123-133 NEW CANTERBURY ROAD LEWISHAM 2049

BOARDING HOUSE DEVELOPMENT

SCHEDULE OF AMENDMENTS

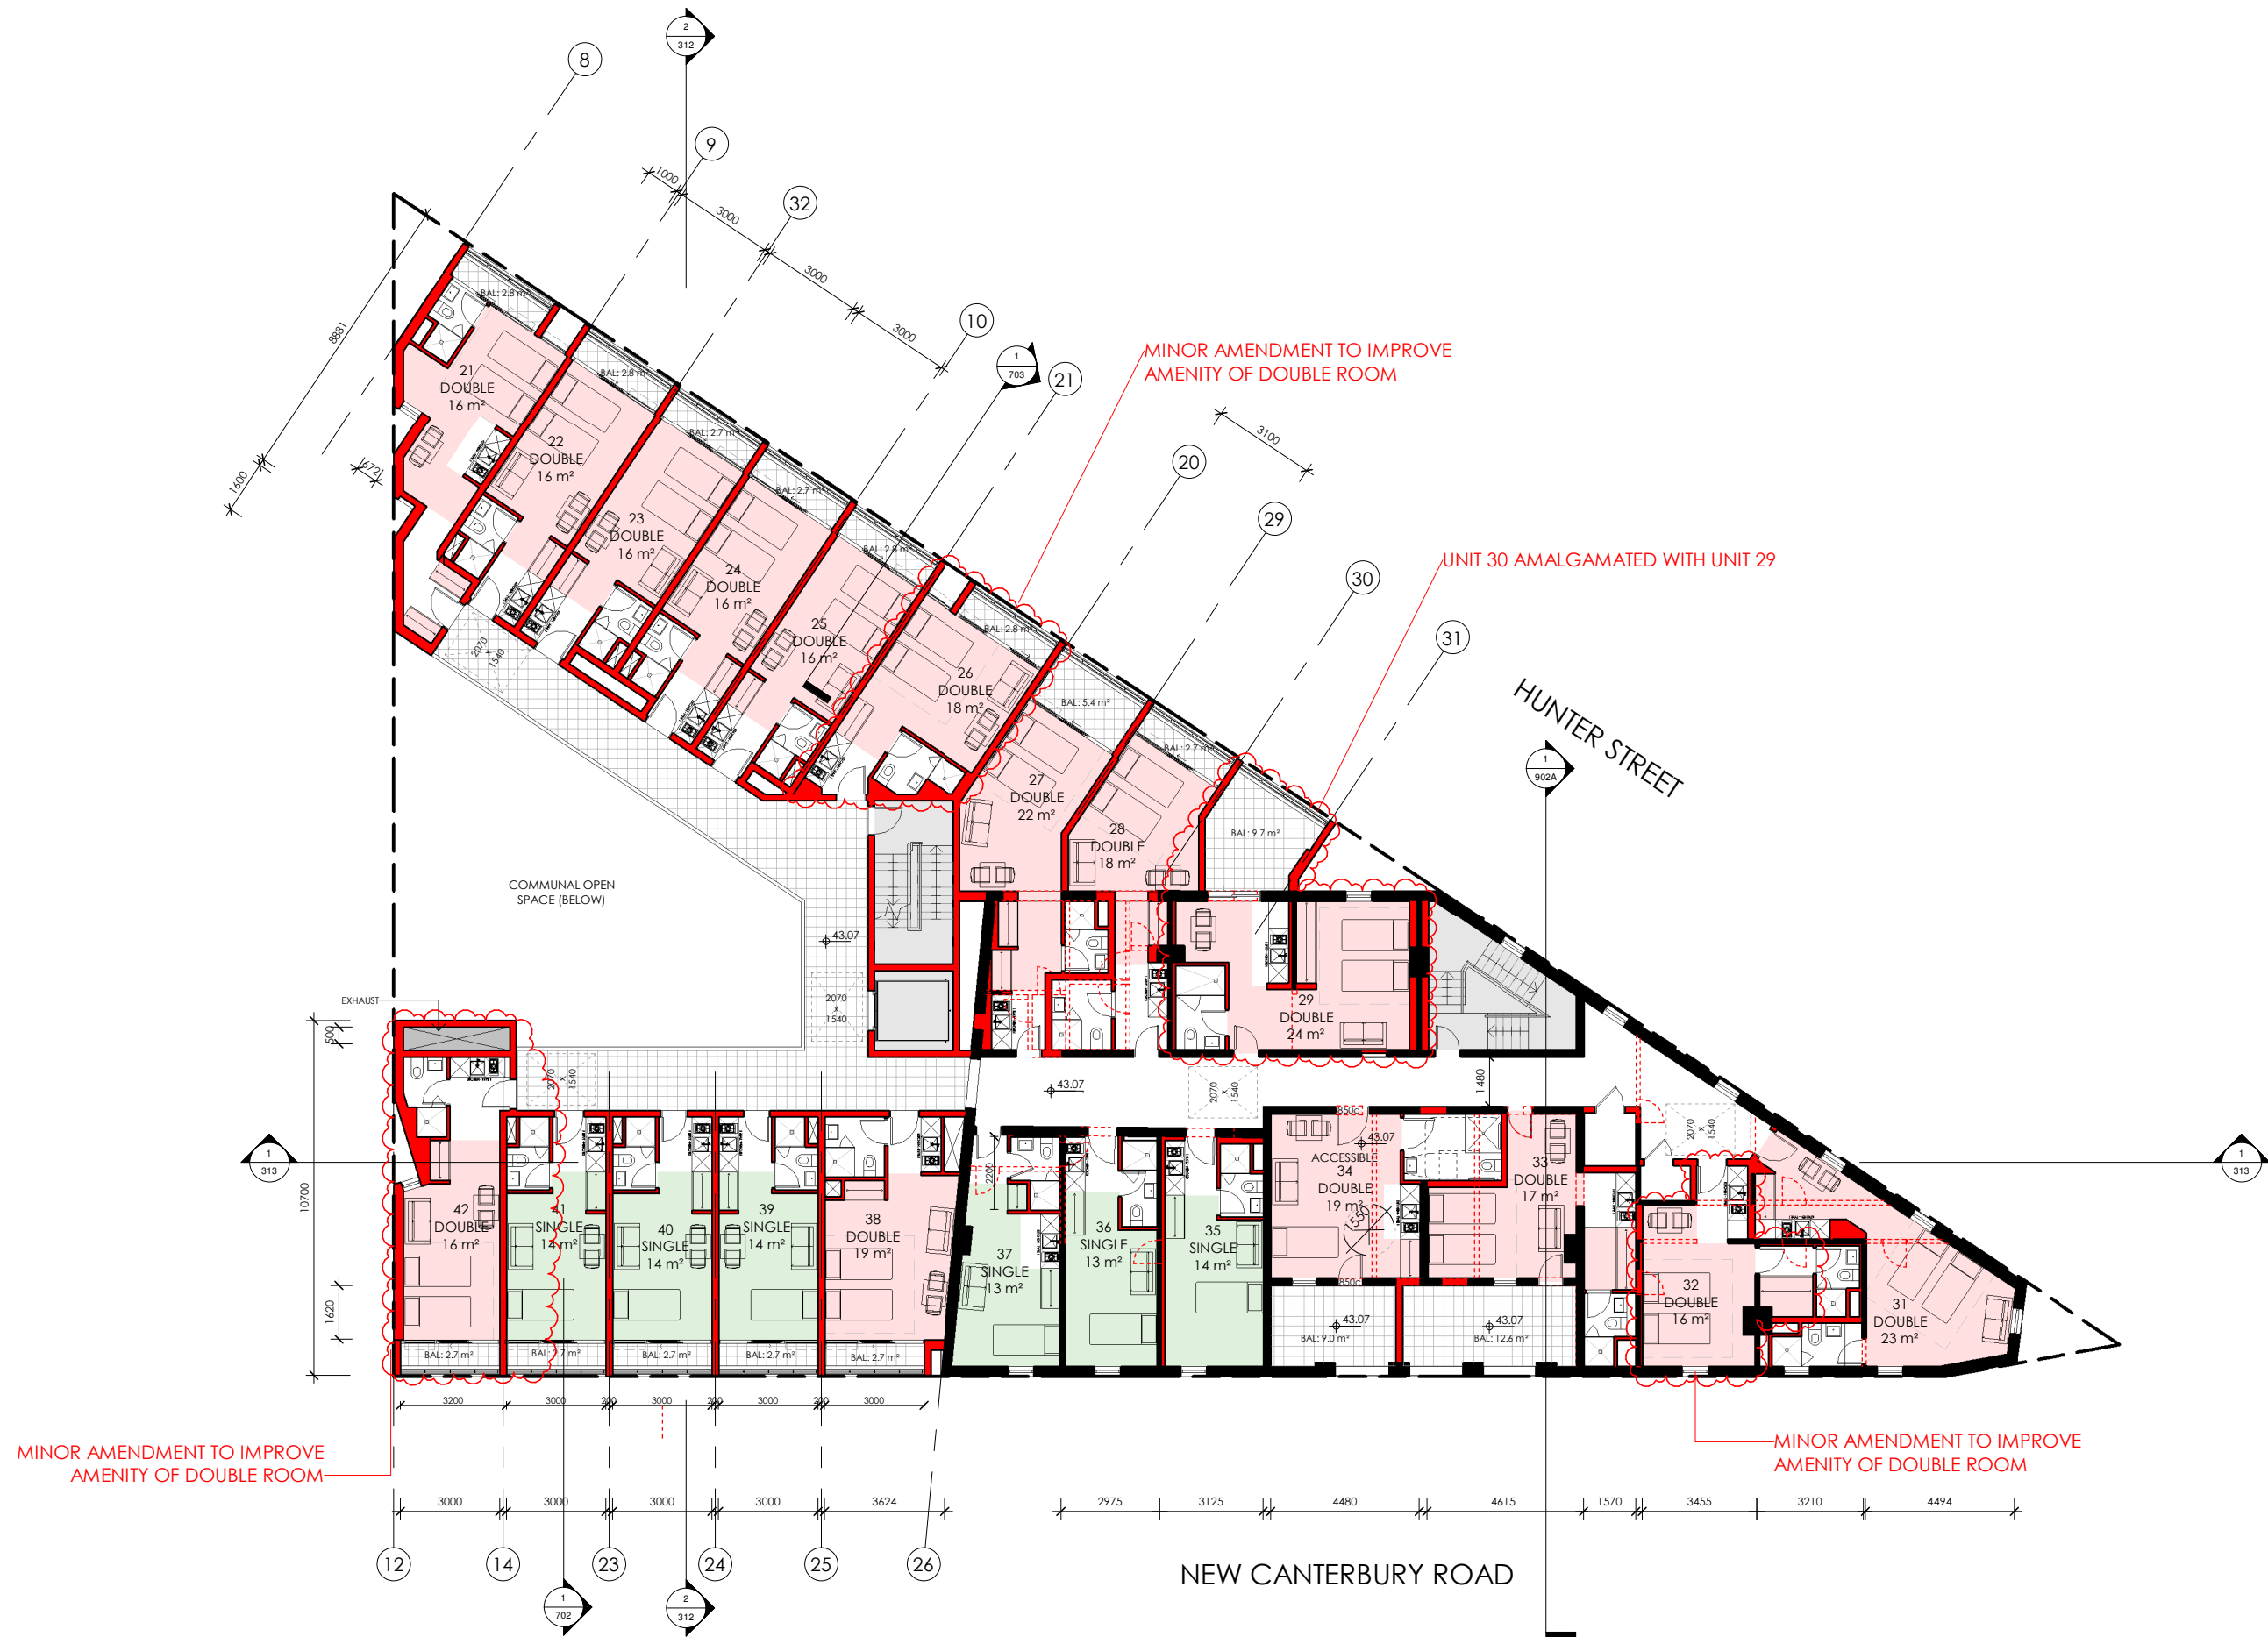
- Room 7 and 8 combined as well as Room 29 and 30 to create 2 double rooms (7, 29).
- Room 10 and 16 are now single rooms.
- GFA calculation updated to include the VIP smoking area and the winter gardens.
- A specification of a car lift has also been added to sheet 904.
